ARCHITECT'S COMMENTS

TITLE		Aston House		DRAWING NO	
Scale		1:10		ECO-00008-002	
Drawn by	JG	Date	31/10/17		
Checked by		Date			
Unless otherwise specified dimensions are in millimeters angles & 2° decimal dimensions & 2mm	D	17/01/18			
	B	01/01/17			
	C	07/01/17			
	AA

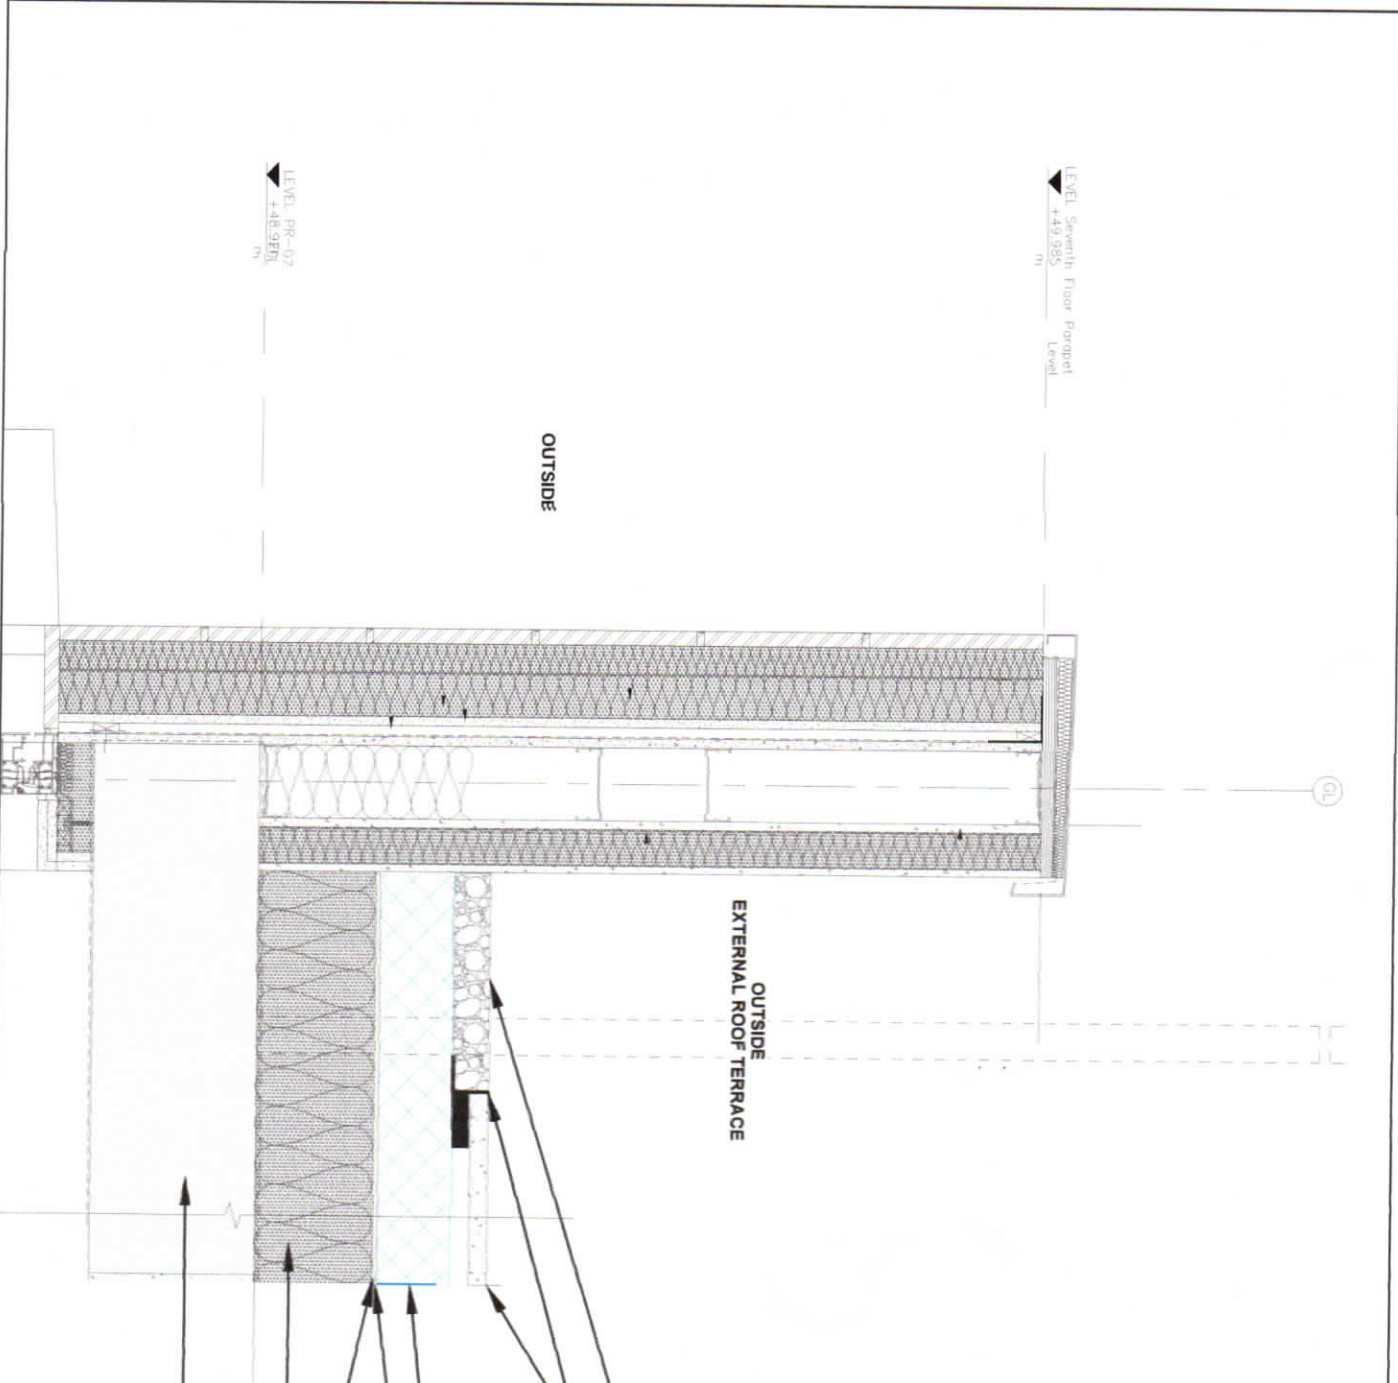
J31 SPEC - 365 for INVERTED ROOF SPEC DOESN'T STATE DETM.

Spec calls for 70mm

Layer thicknesses/products seem slightly different to anticipated build up. Please check Q37 and ensure that all requirements are met.
